Review of Bowden's Response to Groundwater Questions: Bowdens' March 2022 Amendment Report

Release Date: 04 July 2022

Prepared By: Craig Flavel, Senior Hydrogeologist

Lue Station Pty Ltd engaged Field Development Planning (FDP) to review groundwater related matters in the (second) Bowden's Silver Amendment Report dated March 2022.

Figure 1: Water source inflows (R. W. Corkery & Co., March 2022b, p. 20)

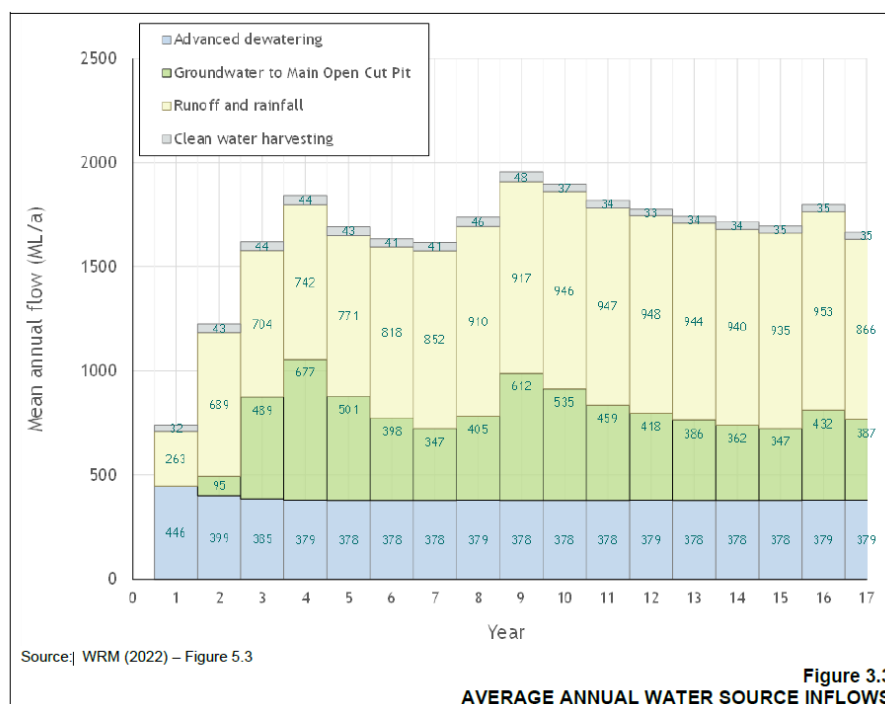
Over 1,000 ML/a of groundwater is expected to be harvested in Year 4. Figure 1 indicates that groundwater yields are not expected to change as open cut pit inflow rates change.

If no hydraulic barrier is modelled between the production bores and the pit, this implies capture and drainage of groundwater recharge over a large area such as the Cudgegong catchment - Figure 3 – or upstream in the Lawsons Creek Catchment. This water would otherwise report to other groundwater users. An updated water model balance (Table 2) provides useful data on where water enters and leaves the groundwater model (bounded by the red polygon in Figure 3). Production from “well” cells in the model is 1,816 ML/a and more work is required to determine how much is from bores within the site water balance.

Figure 2: Biodiversity Study Area - does not extend to Lawsons Creek south of the site in R.W. Corkery & Co. 2022 Appendix 5 (EnviroKey) March 2022.

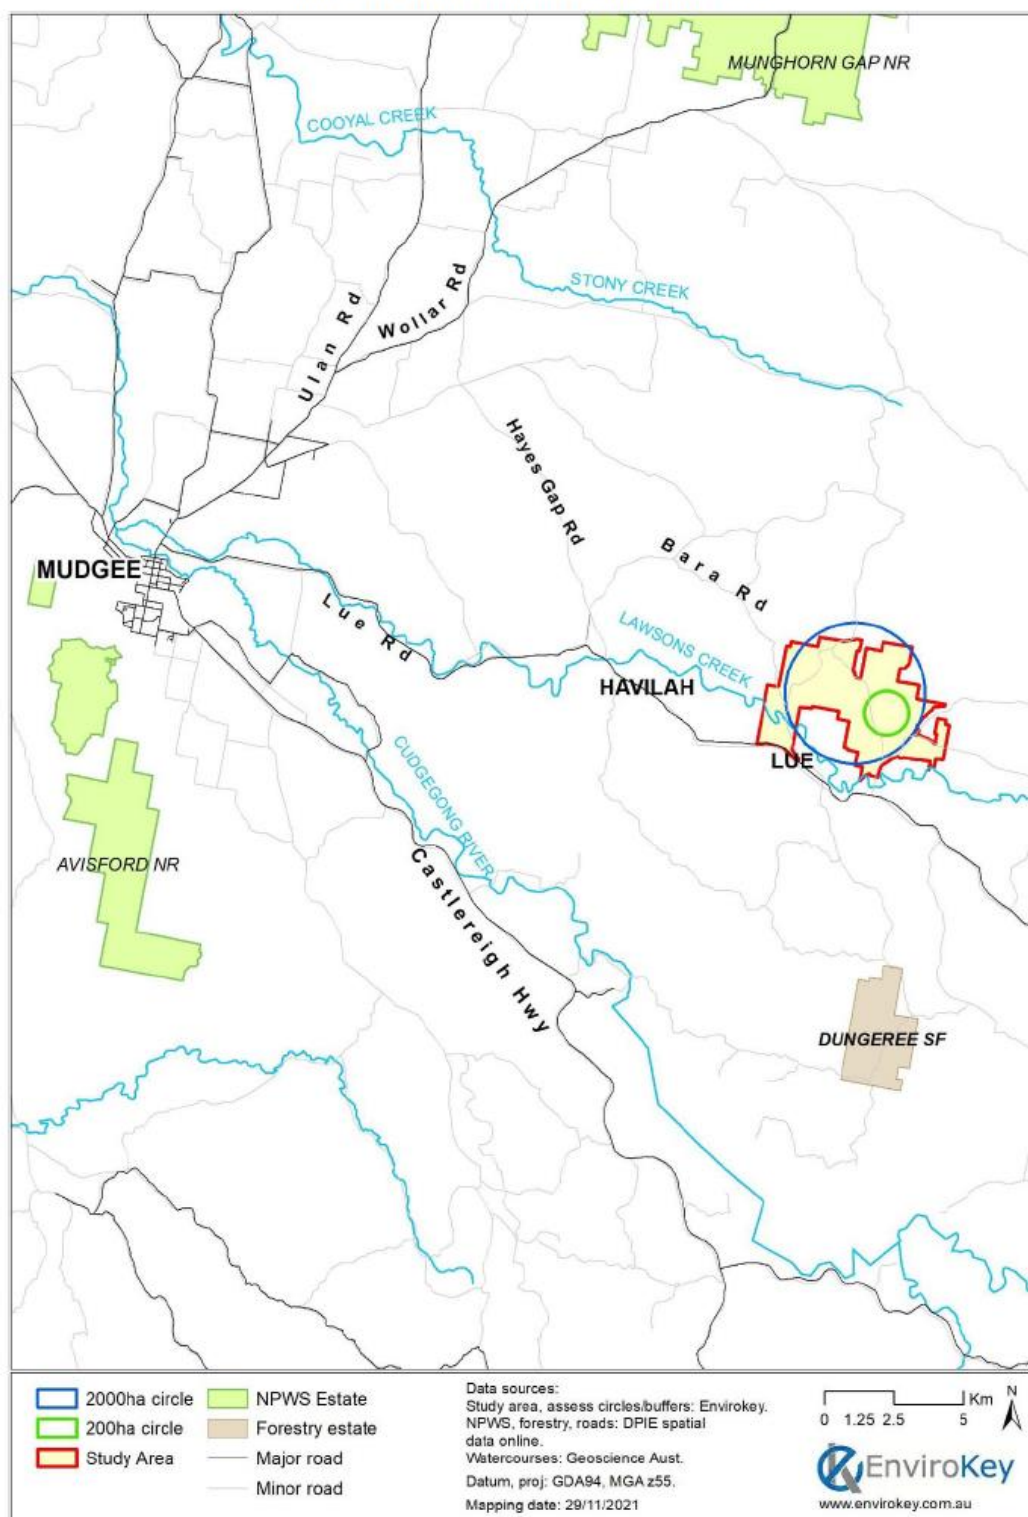
Volume 3 Part 9A – Biodiversity Assessment was updated in March 2022, however, EnviroKey were not advised that proposed disturbances might extend beyond previously surveyed areas due to the increased groundwater extraction proposed. In other reports, a permanent reduction in streamflows around the site due to reduction of rainfall run-off and a reduction in baseflow from groundwater is predicted (R.W. Corkery & Co., March 2022c, pp. ES-24). The disturbance is thus beyond the Study Area EnviroKey has been directed to consider (Figure 2).

Figure 6: Modelled thickness of combined Layers 1 and 2 (R. W. Corkery & Co., 2022d, pp. 5-397)

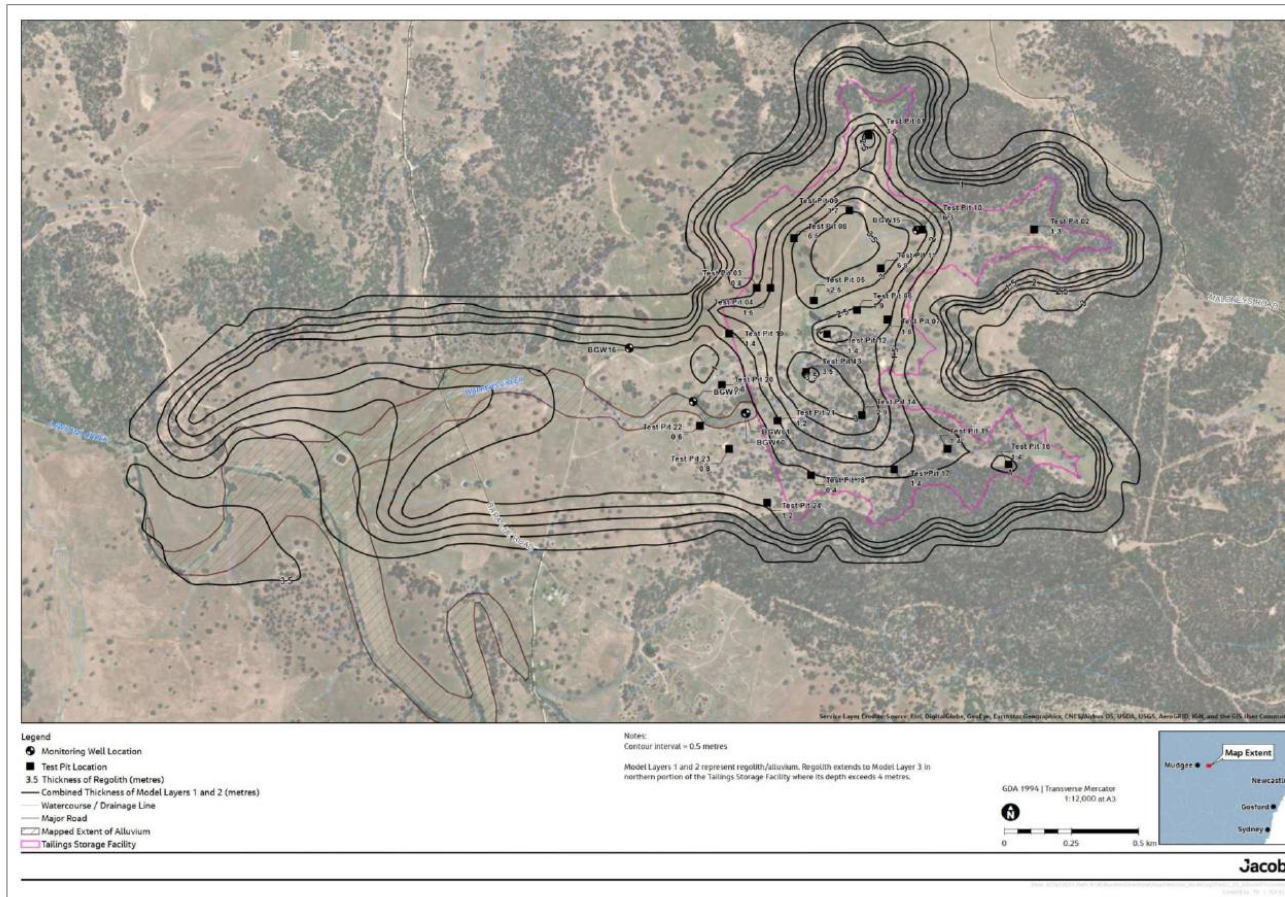
Figure 6 shows the modelled thickness of the upper two layers, but does not provide any guidance regarding the assumptions (e.g. geological logs) supporting this hydrogeological interpretation. Figure 7 and Figure 8 show the impact of the altered hydrogeology on modelled groundwater drawdown impacts; acid leachate is modelled to report to the pit in the outputs provided, not the creeks.

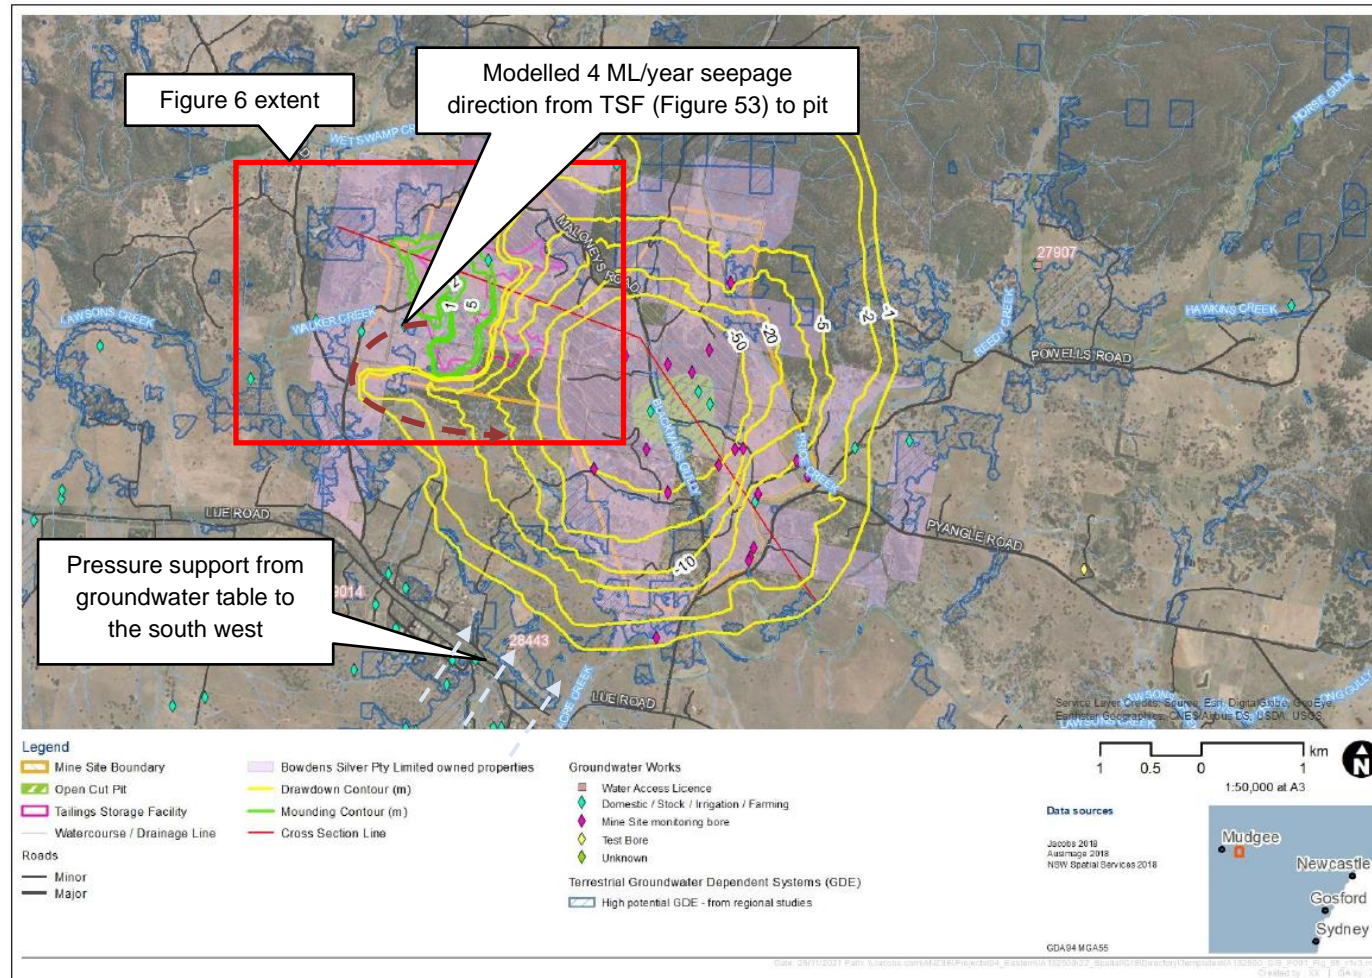
Figure 7: 2022 Year 9 modelled drawdown, influenced by zone/layer distribution, modified from (R. W. Corkery & Co., 2022d, pp. 5-127), showing hydraulic communication between the TSF and the pit, indicating leakage / pressure support from the TSF reporting to the pit as well as groundwater pressure support from the south west. NB. Figure 53 appears to mislabel Option 1 and Option 2 with BGM.
